file	48T	
Size	Document Number	Rev
C	<Doc>	xx2
date	Thursday, September 09, 2004	Sheet 1 of 1

COMPANY:		TITLE:	
GA-48		CODE:	SIZE:
DRAWN:	DATED:	DRAWING NO.:	REV.:
CHECKED:	DATED:	SCALE:	SHEET: OF
QUALITY CONTROL:	DATED:		
RELEASED:	DATED:

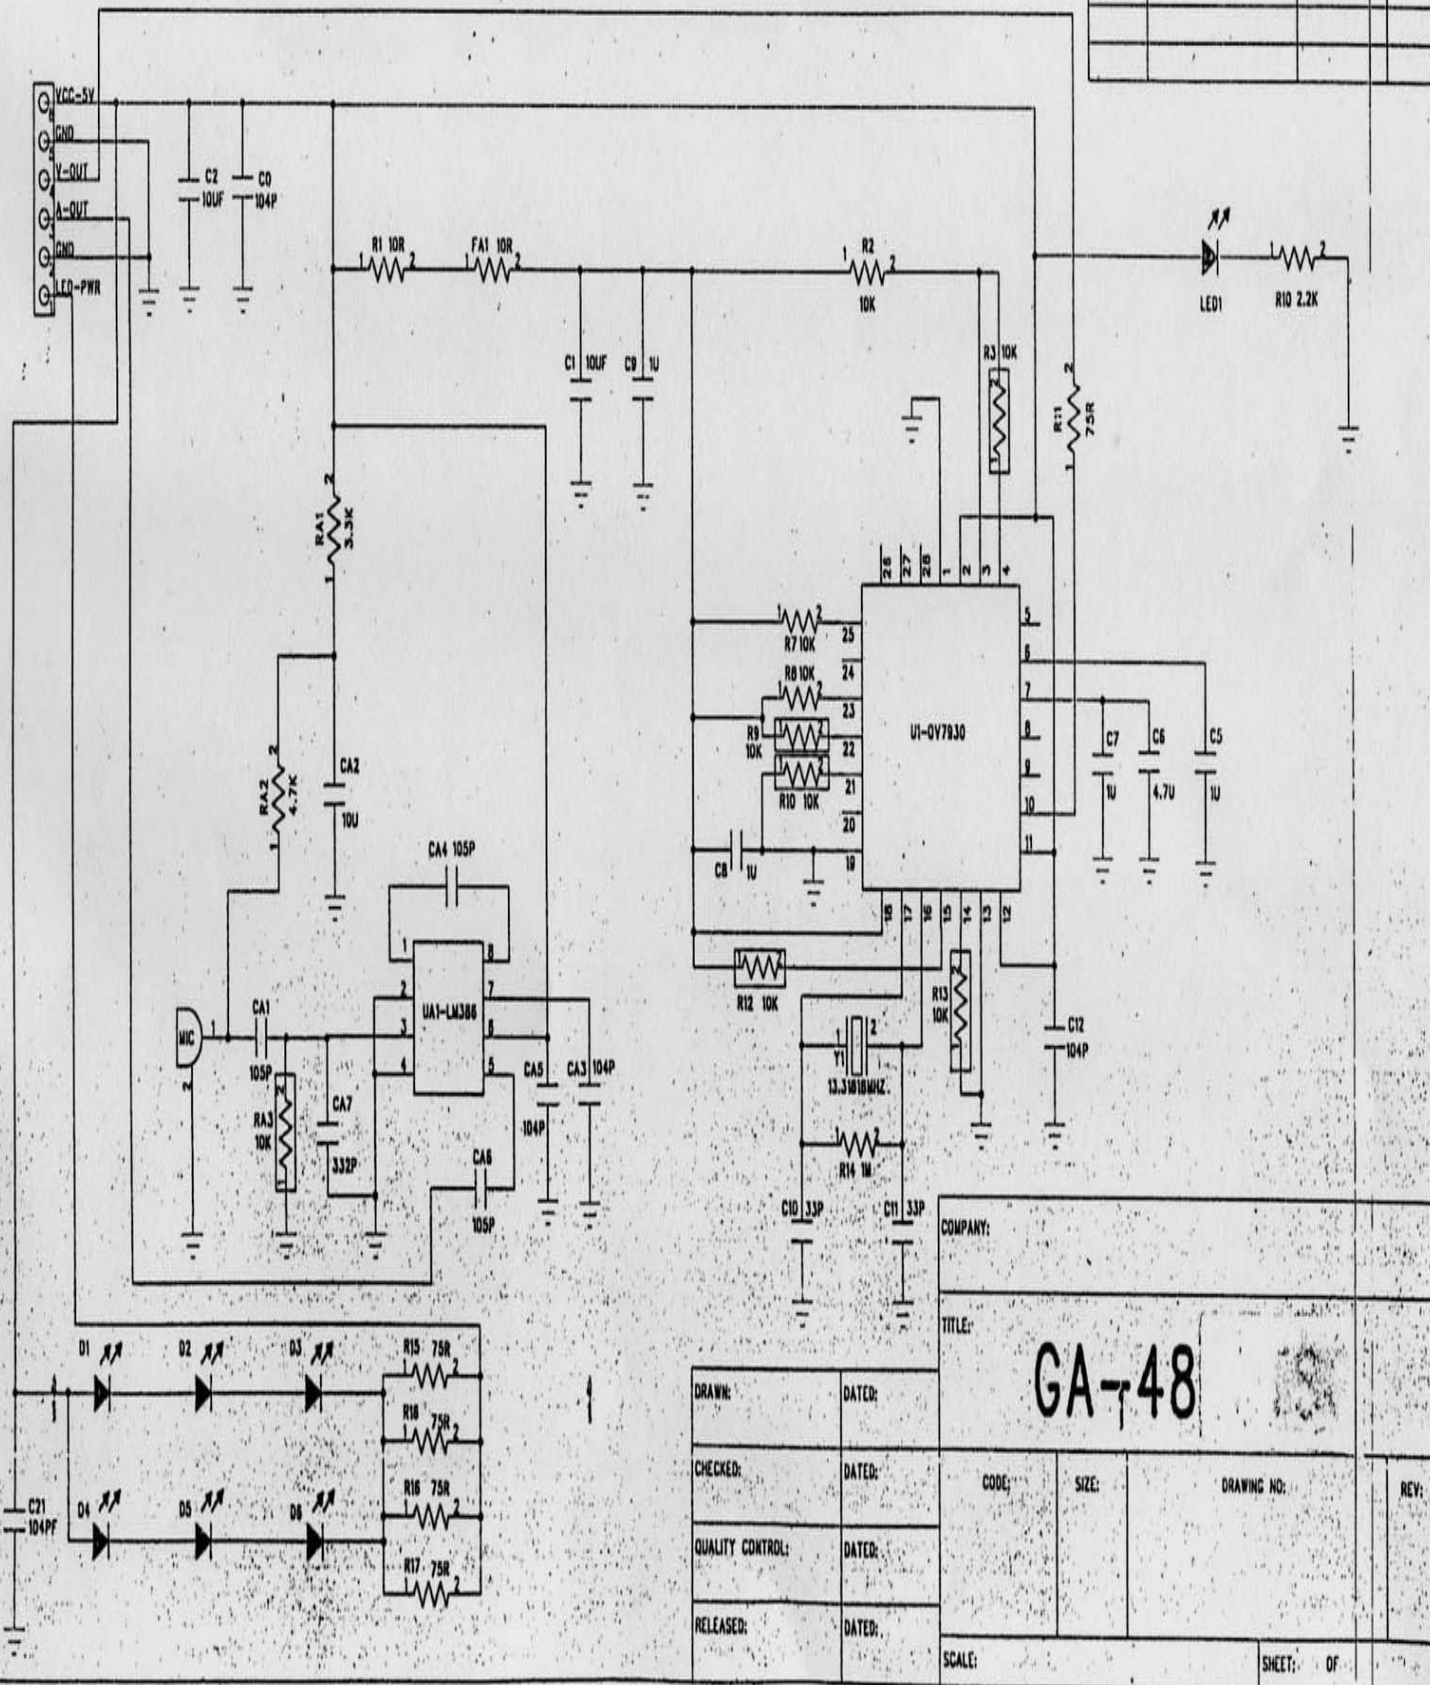
Note : x3 modify list :
 a. J1 pin 6,7 add net name pwr1,pwr2 for layout purpose.
 b. correct the RF_PWR_CTL2 to RF_PWR_CTL2 at U2.18
 c. add test pin. TP1,TP2 for battery power,TP3 for GND.
 d. move the feedback resistor position of U3,U4 After Cap.

Note : x4 modify list :
 a.Add C26,C27 at J1.1 to provide more good power supply to camera module
 b. change the U1.18 net name from RF_PWR_CTL2 ==> BAT_LED_CTL, U1.1 from BAT_LED_CTL ==> RF_PWR_CTL2 for layout avoid the crossconnection.

Note : xx2_1 modify list :
 a.Add D7,D8(1N4002) for reduce the adp_pwr from 7V to 5.5V samw as battery voltage

Note : xx2_2 modify list :
 a. Modify the power path D8 and add D9 to separate Pwr_bat and Pwr_adp
 b. add pull_low resistor R57 for default power input selection
 c. modify the power led source to power_status
 d. modify the Bat+,Bat- test point for solder issue
 e. modify the R9 package to 1210 for power consumption issue
 f. add U8,U9 LDO for quality issue
 g. add D10 to protect the Battery
 h. Q3, R48,R52 should replacement to avide interference w with GM
 i. change U3,U4 from MP1523 to MP1518
 j. add R58 for pull low PWM control
 k. add C28 for quality issue
